Buildings R4A & R4B Barangaroo South Modifications

Design changes

State Significant Development Modification Assessments
(SSD 6964 MOD 4, SSD 6965 MOD 3 & SSD 8892218 MOD 1)

April 2022

Figure 3 | Proposed two trees to be deleted for Building R4A (source: SSD 6964 MOD 4 RTS Landscape Reference Plan)

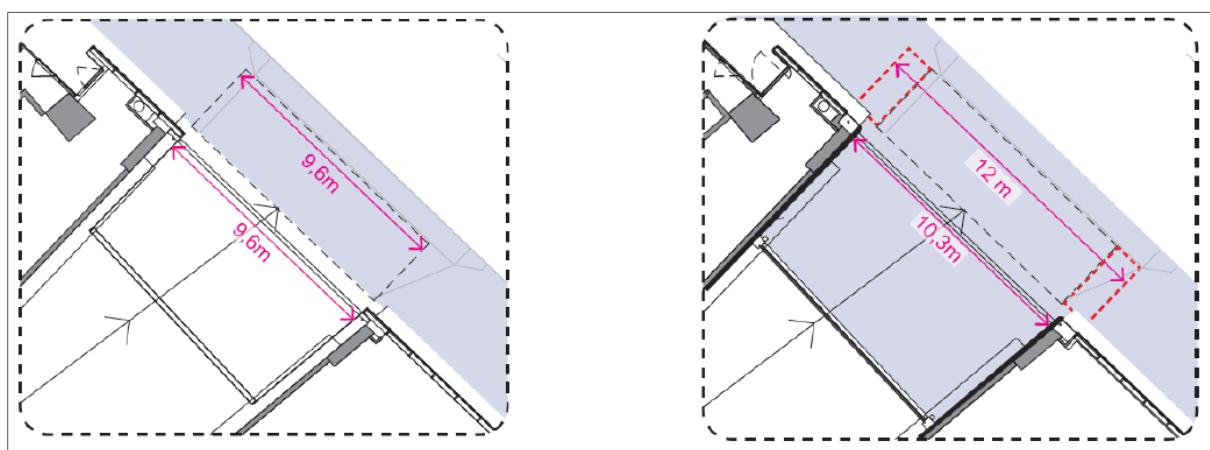
- sought clarification on how wide the driveway opening is proposed to be increased, noting it generally recommends carpark openings have a maximum width of 4 m accordance with the Sydney Development Control Plan 2012 (DCP)
- questioned the need for the removal of the two trees when considering the long-term impacts of the trees on sightlines to Hickson Park.

- the widening of the driveway departs from the objectives of the DCP recommendations to minimise driveway widths to prioritise pedestrian and cyclist safety and amenity
- the two trees should be planted, as approved, as the benefits of additional canopy outweigh potential view impacts.

Issue	Consideration	Recommendation
Landscaping	<ul style="list-style-type: none">• The proposals seek to delete two <i>Flindersia australis</i> trees from the approved landscape plan.• The Applicant notes these trees formed part of the original development consent approved in 2017, prior to the approval of Hickson Park in 2018.• Council raised concern about the deletion of these trees because of benefits to pedestrian amenity in relation to wind protection, shading and heat mitigation.• In response, the Applicant noted that the approved and delivered landscaping within Hickson Park provides a substantial tree belt of approximately 53 trees framing the paved public open space around Buildings R4A, R4B and R5. It contends the two trees within the paved area are inconsistent with this strategy of tree planting and will impact on pedestrian circulation around the building.• The Applicant also provided a Wind Statement which concludes that the deletion of the two trees will have a negligible impact upon the wind environment conditions within the areas assuming that all other previous wind mitigation treatment recommendations are incorporated into the final design.• The Department has carefully considered the proposed deletion of two trees from the landscape plan and acknowledges that Council maintains its position that the trees should be planted in this location, as approved.• The Department supports tree planting and improving tree canopy cover within urban developments, however in this instance considers there is sufficient justification to delete these trees as:<ul style="list-style-type: none">◦ Hickson Park provides substantial trees including a 'tree belt' adjacent to Buildings R4A, R4B and R5◦ 17% of the Stage 1B site (comprising Buildings R4A, R4B, R5 and Hickson Park) is covered in tree canopy, which exceeds Council's 15% tree canopy target	<ul style="list-style-type: none">• Update Condition A2 for SSD 6964 and SSD 6965 and Condition A6 for SSD 8892218 to reflect the amended landscape plans

Issue	Consideration	Recommendation
	<ul style="list-style-type: none"> ○ the deletion of the trees will allow for the paved area to be maintained as clear area for pedestrian circulation between the buildings and Hickson Park ○ the trees are not required for wind mitigation, and the deletion is unlikely to have significant impacts on the heat environment, given the extent of tree planting on the edges of Hickson Park. ● The Department therefore concludes, in this instance, the deletion of the two trees would not have any material impact on tree canopy coverage, wind or heat environment in the context of the dense landscaping in Hickson Park. 	
Amendment to car park entrance	<ul style="list-style-type: none"> ● The proposal seeks to widen the basement entry driveway and change associated awning, wall cladding and paving for Building R4B to reduce the risk of vehicles colliding with and damaging the building when entering or leaving the carpark. ● Council raised concern that the driveway width exceeds the recommended maximum width of 4 m within its DCP and does not prioritise pedestrian and cyclist safety and amenity. ● The Applicant provided Statements on traffic, Building Code of Australia 2019 (BCA), and access which conclude that the proposed design complies with the relevant standards. ● The Department notes that Council did not raise any concerns on the approved driveway width of 9.6 m in the assessment of the original SSD application for Building R4B. It also notes that as the driveway provides a combined entry and exit point it is not feasible to comply with the DCP recommended maximum of 4 m (which would only allow entry or exit). ● In this context, the Department is satisfied the proposed increase in width will not result in any material change to pedestrian and cyclist safety and amenity as: <ul style="list-style-type: none"> ○ the increase is minor (0.7m or 7%) compared to the approved 9.6 m driveway ○ the proposal will not increase the traffic volume entering and exiting the site in this location ○ the widening will reduce the potential conflicts with cars and loading services approaching in opposite directions and the risk of vehicles impacting the building when entering or leaving the site. 	<ul style="list-style-type: none"> ● Update Condition A2 for SSD 6964 and SSD 6965 and Condition A6 for SSD 8892218 to reflect the amended architectural plans

- the deletion of two trees from the landscape plan will ensure the paved area between Hickson Park and Building R4A is maintained for pedestrian circulation and will have a negligible impact on the wind and heat environment and tree canopy coverage, noting the extensive trees planted within Hickson Park

Figure 5 | Approved and proposed development boundary of Building R4A (SSD 6964) (source: SSD 6964 MOD 4 Design Report)

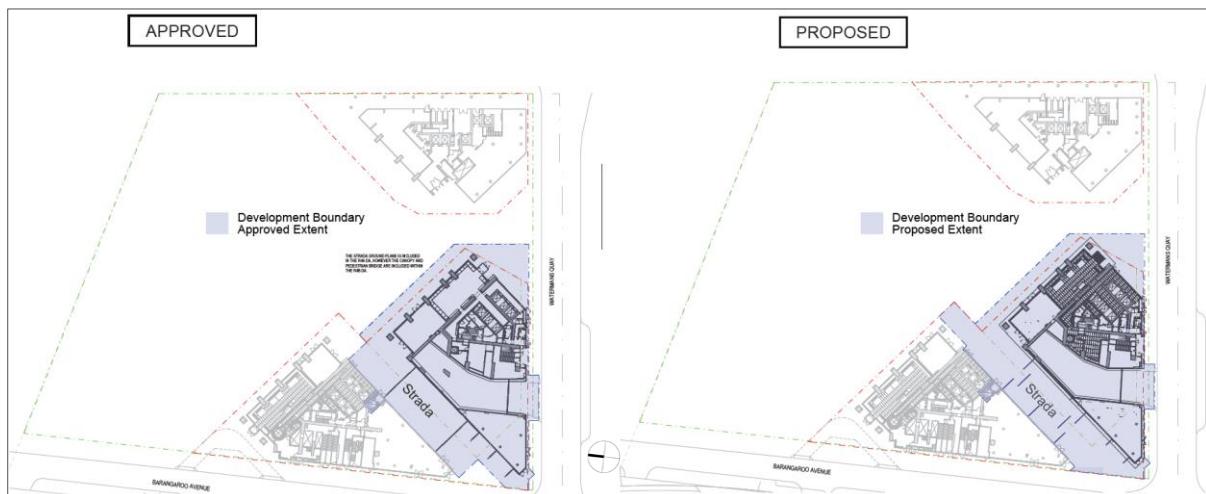
Strada	<ul style="list-style-type: none"> ● The 'Strada' is a covered pedestrian through site link between buildings R4A and R4B to Hickson Park. The ground plane is approved within the development consent for R4A, however the canopy and other above ground works are approved within the development consent for R4B. ● The proposals seek to amend the boundary between Buildings R4A and R4B so that the approved Strada is contained within and delivered as part of the development consent for Building R4B. ● Council raised no objection to these proposed changes. 	<ul style="list-style-type: none"> ● Delete Conditions A5, B5, E4, F1, and F2 and relevant references to the Strada in development description, Conditions B30, B39, E24, E29 and F15 from SSD 6964 ● Add Conditions A5A, E29, F19, F20 and

Issue	Consideration	Recommendation
	<ul style="list-style-type: none"> The Department has carefully considered the proposed boundary change and supports the delivery of the Strada as part of Building R4B as: <ul style="list-style-type: none"> the proposals will not result in any physical change to the approved built form, and the Strada will continue to provide a covered walkway between Buildings R4A and R4B to Hickson Park it will better align with the construction and delivery of the Strada by consolidating both the ground plane and canopy together under one consent there will be negligible difference to the timing of completion of the Strada as Buildings R4A and R4B are concurrently under construction. 	<ul style="list-style-type: none"> relevant references to the Strada to the development description and Conditions B28 for SSD 6965 Update Condition A5 for SSD 8892218 to reflect the added conditions of SSD 6965 and add relevant references to the Strada to the development description for SSD 8892218 Update Conditions A2 for SSD 6964 and SSD 6965, and Condition A6 for SSD 8892218 to reflect the amended architectural plans

- the transfer of Strada from Building R4A to Building R4B does not alter the approved built form, will consolidate both the ground plane and roof together under one consent and will better align with the construction and delivery of Building R4B

Figure 7 | Approved building identification signage zone(s) of Buildings R4A (left) and R4B (right) (source: SSD 6964 MOD 3 & SSD 6965 MOD 2 stamped plans)

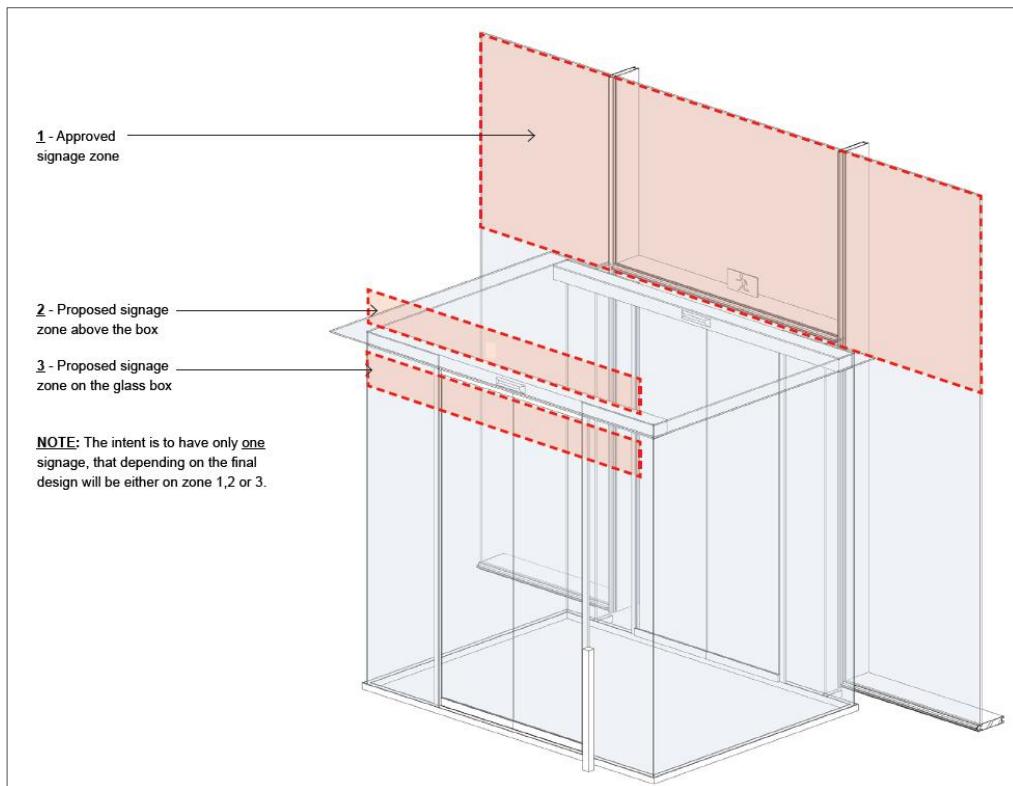
Amendment to signage zone(s)	<ul style="list-style-type: none"> The development consents approve two signage zones for Building R4A and one signage zone for Building R4B. The proposals seek to provide three separate signage zones (only one to be used) for both Buildings R4A and R4B, including: <ul style="list-style-type: none"> an approved signage zone on the façade (11 m²) a proposed signage zone on top of the glass entryway (0.9 m²); or a proposed signage zone on the upper portion of the glass entryway (0.6 m²). Council did not raise any objection to these proposed changes. The Department notes that Control 9 in the Concept Approval Design Controls stipulates signage is to be 	<ul style="list-style-type: none"> Update Condition 11 for SSD 6964 and add a new Condition 10 for SSD 6965 restricting future signage to be located within only one of the three signage zones to ensure consistency with the concept approval Update Condition A2 for SSD 6964 and SSD 6965 and Condition A6 for SSD 8892218 to

Issue	Consideration	Recommendation
	<p>limited to one sign per frontage at podium level and is not to exceed 15 m² per sign.</p> <ul style="list-style-type: none"> The Department considers the proposed alternative signage zones are acceptable as: <ul style="list-style-type: none"> they meet the key criteria in Chapter 3 of State Environmental Planning Policy (Industry and Employment) 2021 (former SEPP No.64 – Advertising and Signage) (Appendix C) the areas of the three zones are no more than the requirements in the Concept Approval the proposed additional signage zones are small, which will result in negligible visual impacts they will provide flexibility for potential signage locations noting that only one of the three signage zones can be utilised future DA(s) will be required, unless the signage can be undertaken as exempt or complying development. The Department recommends amended/new conditions on SSD 6964 and 6965 to ensure a maximum of one signage zone for each building is utilised. 	reflect the amended signage zones
